SERVICE BULLETIN

From the 21st week of 2002, on the 70cm built-in ovens and from the 24th week on the 90cm ovens (see table on page 3), the code 811730221 NEW (CF) will be purchased from supplier E.G.O., instead of BERNHARDT & SCHULTE KG (B&S), maintaining the same connection type.

COMUTATORE FUNZIONI Dreefs cod. 81 173 0142										
POS.	1a	2a	3a	4a	5a	6a	7a	8a	9a	10a
0										0
1										1
2										2
3										3
4										4
5										5
6										6
7										7
8										8
	1	2	3	4	5	6	7	8	9	10

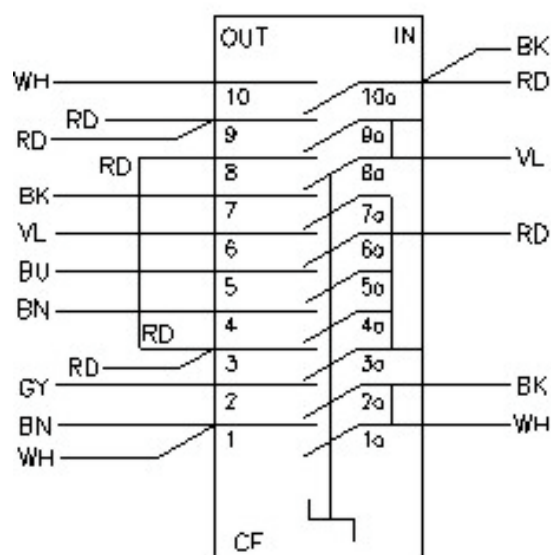
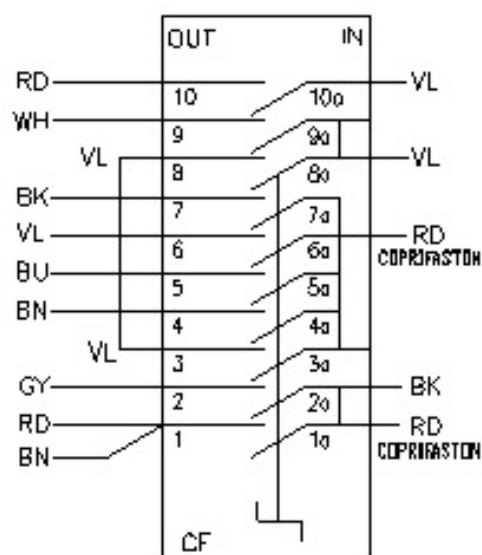
NB: in case of substitution, in service, you must keep present that the numeration 1-2-3-4-5-6-7-8-9-10 of a supplier corresponds to 1a-2a-3a-4a-5a-6a-7a-8a-9a-10a from the other and vice versa; for example, a wire on contact 1 of the OLD B&S commutator must be inserted on contact 1a of the E.G.O. commutator.

Change from NEW TF = 811730221 (B&S) in OLD TF = 811730142

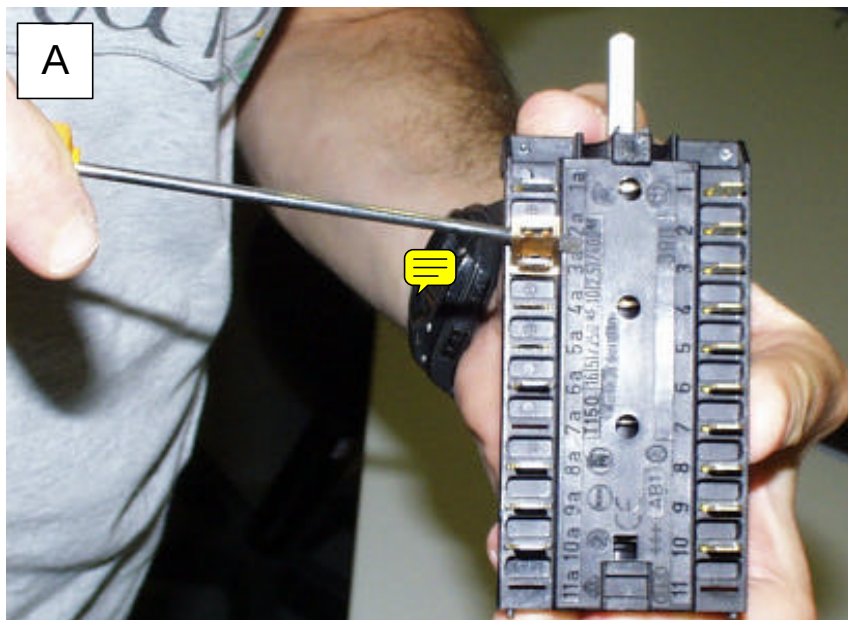
In case it is necessary to replace code 811730142 (CF) OLD, it is possible to mount a commutator code 811730221 (CF) NEW taking out the copper jumper (PR), carrying out an easy operation, as shown in the following picture (A).

CF = 811730221 (E.G.O.)

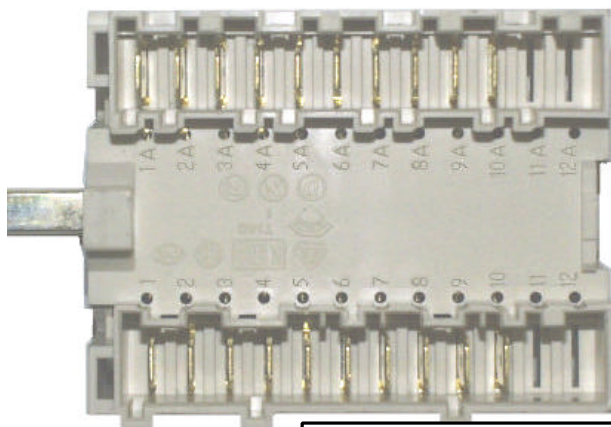
NB: the NEW (TF) commutator code 811730221 E.G.O can not replace the OLD TF black commutator code 811730142, supplied by BERNHARDT & SCHULTE KG (B&S).
